[Docket No. 99-NM-87-AD; Amendment 39-11138; AD 99-08-51]

Airworthiness Directives; McDonnell Douglas Model MD-11 Series Airplanes

99-08-51 BOEING: Amendment 39-11138. Docket 99-NM-87-AD.

Figure 1

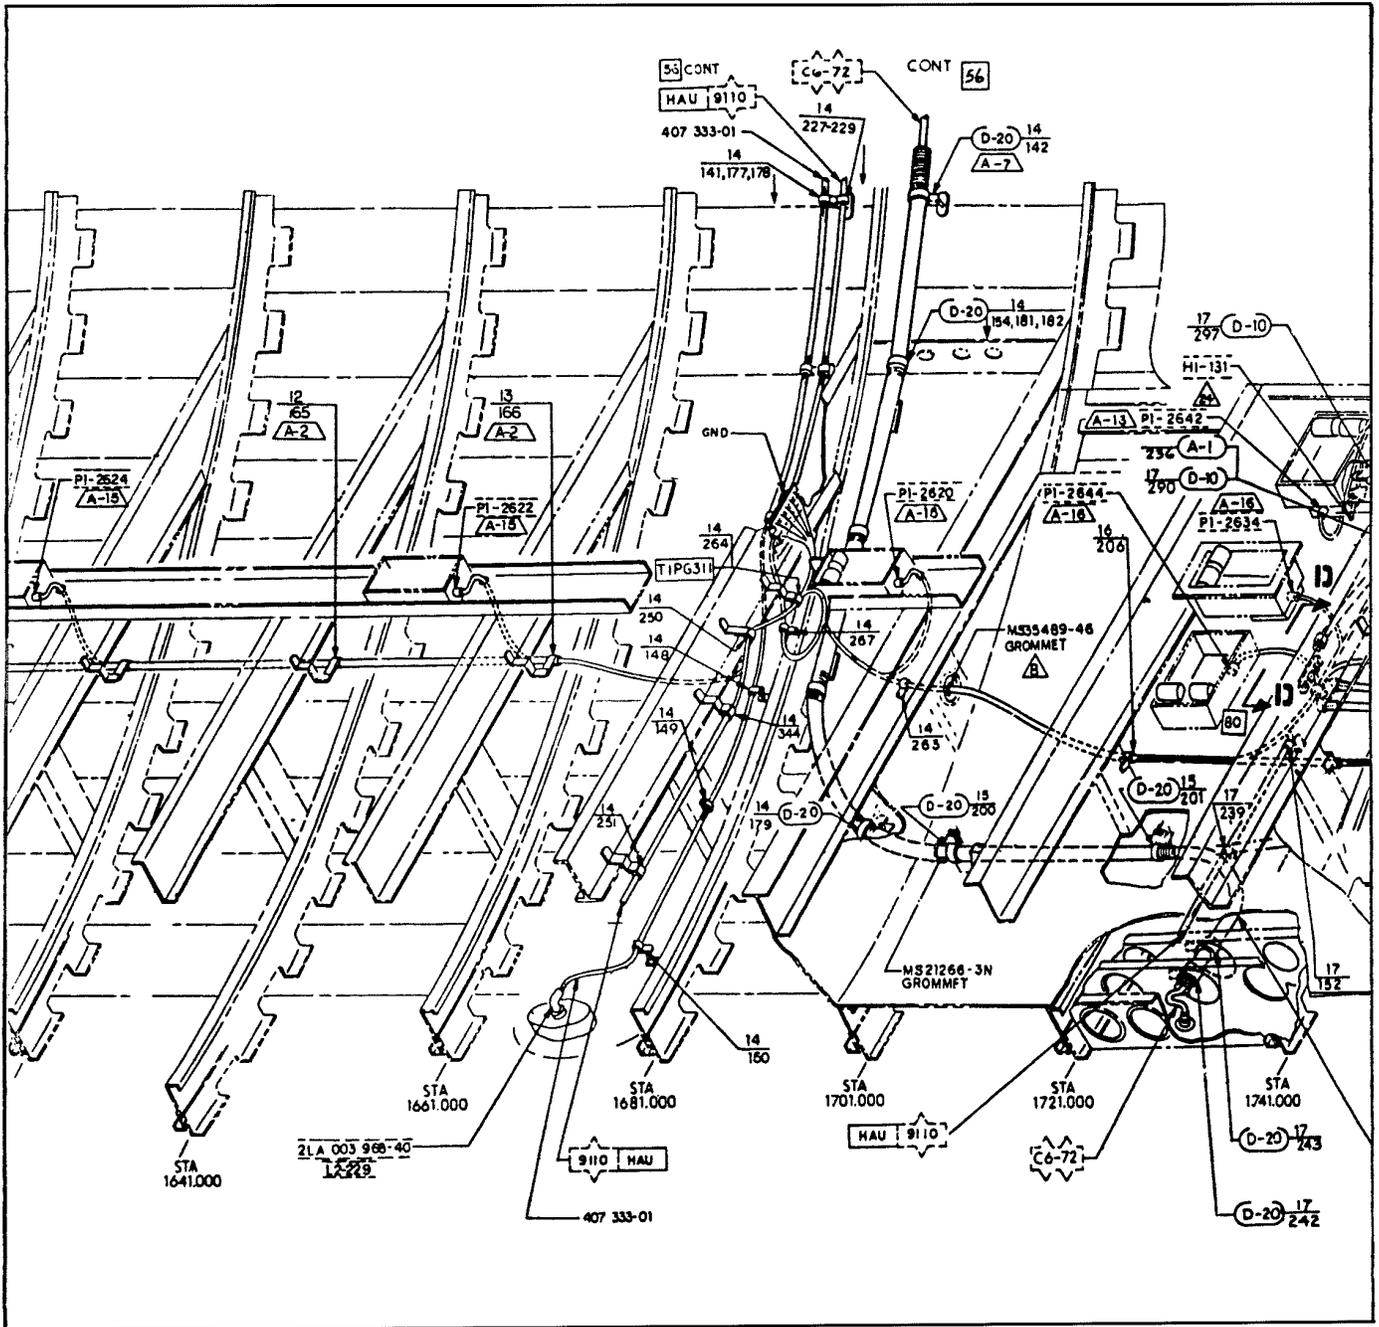
(a) Within 15 days after the effective date of this AD: Perform a one-time visual inspection under the floorboards in the lower center cargo compartment at frame 1681 (approximately one inch outboard of longeron R46) to verify that a bracket having part number P/N 9D0062-3-16-24 (or equivalent), and an open face nylon clamp having P/N NMC1001-1 or 383-1 (see Figure 1, Item 14/267), are installed to support wire bundle No. AGS9110.

(1) If the bracket and clamp are installed: Prior to further flight, perform a visual inspection to detect damage of the subject wire bundle. If any damage is detected, prior to further flight, accomplish paragraphs (a)(1)(i) and (a)(1)(ii) of this AD.

(i) Repair in accordance with Chapter 20-30-01 of the McDonnell Douglas MD-11 Airplane Maintenance Manual. And

(ii) Install a silicone rubber coated with a glass cloth protective wrap [Douglas Material Specification (DMS) 2109 or equivalent] around the wire bundle in the area over frame 1681 above stringer R46 in accordance with Chapter 20-10-01 of the McDonnell Douglas MD-11 Wiring Diagram Manual.

(2) If the bracket or clamp is not installed: Prior to further flight, perform a visual inspection to detect damage (i.e., chafing, damage, or missing wire insulation) of the subject wire bundle.

(i) If no damage is detected: Prior to further flight, install a silicone rubber coated with a glass cloth protective wrap (DMS 2109 or equivalent) around the wire bundle in the area over frame 1681 above stringer R46 in accordance with Chapter 20-10-01 of the McDonnell Douglas MD-11 Wiring Diagram Manual.

(ii) If any damage is detected: Prior to further flight, accomplish the actions required by paragraphs (a)(1)(i) and (a)(1)(ii) of this AD.
